RECORD PLANS

STATE OF VERMONT
AGENCY OF TRANSPORTATION

MIDDLEBURY–WEYBRIDGE
BHO 1445(33)

PROJECT DESCRIPTION: REHABILITATION OF THE PULP MILL COVERED BRIDGE CONSISTS OF REPLACING THE DETERIORATED BRIDGE MEMBERS, INSTALLATION OF NEW SIDING AND A NEW METAL ROOF, SUBSTRUCTURE REPAIRS, INSTALLATION OF APPROACH RAILING AND RECONSTRUCTION OF ROADWAY APPROACHES.

ROADWAY PLAN

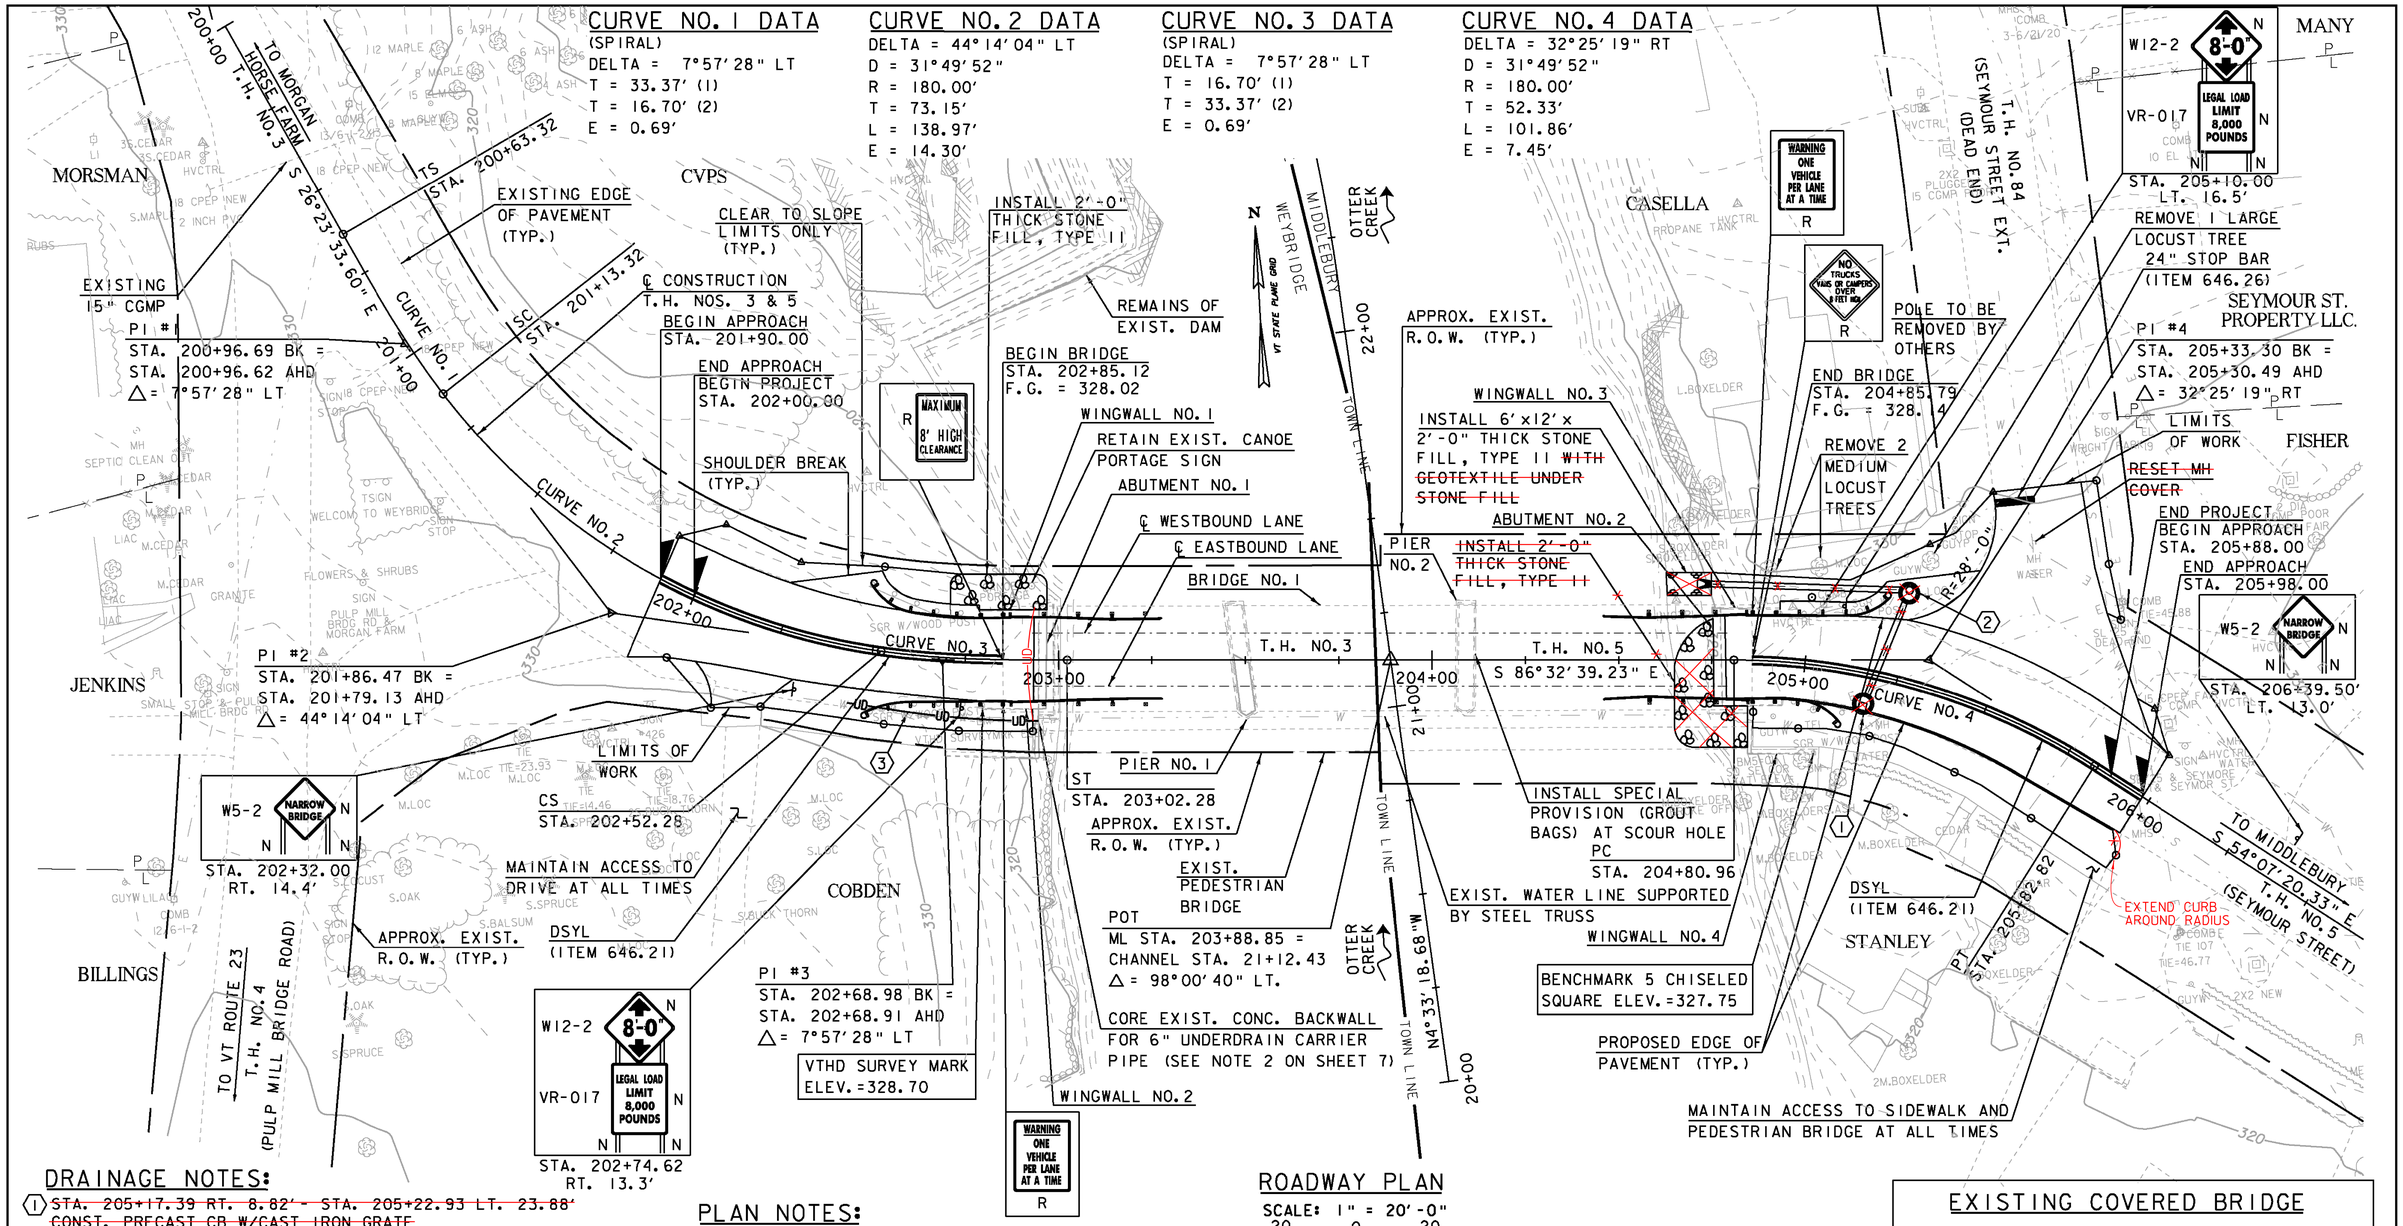
1. ~~STA. 205+17.39 RT. 8.82' - STA. 205+22.93 LT. 23.88'~~
   ~~CONST. PRECAST CB W/CAST IRON GRATE~~
   ~~(ADJUST AS NECESSARY TO PROVIDE 12" MIN. CLEARANCE TO EXISTING WATER MH)~~
   ~~INV. OUT ELEV. 320.58~~
   ~~GRATE ELEV. 327.29 (SLOPE PAVEMENT TO DRAIN TO GRATE)~~
   ~~CONST. 30'x18" DRAINAGE PIPE (SEE QUANTITY SHEETS FOR ALLOWABLE PIPE OPTIONS)~~

2. ~~STA. 205+22.93 LT. 23.88' - STA. 204+72.47 LT. 20.11'~~
   ~~CONST. PRECAST MH W/CAST IRON COVER~~
   ~~INV. IN ELEV. 320.43~~
   ~~INV. OUT ELEV. 319.93~~
   ~~COVER ELEV. 327.61~~
   ~~CONST. 54'x18" DRAINAGE PIPE W/END SECTION (SEE QUANTITY SHEET FOR ALLOWABLE PIPE OPTIONS)~~
   ~~INV. OUTLET ELEV. 319.66~~

3. STA. 202+42.3± RT. - STA. 202+~~93.3~~ 90 LT
   REPLACE EXIST. UNDERDRAIN WITH 6" UNDERDRAIN PIPE AND CONNECT TO EXIST. UNDERDRAIN. CONST. 6" UNDERDRAIN CARRIER PIPE (SEE NOTE 2 ON SHEET 7)
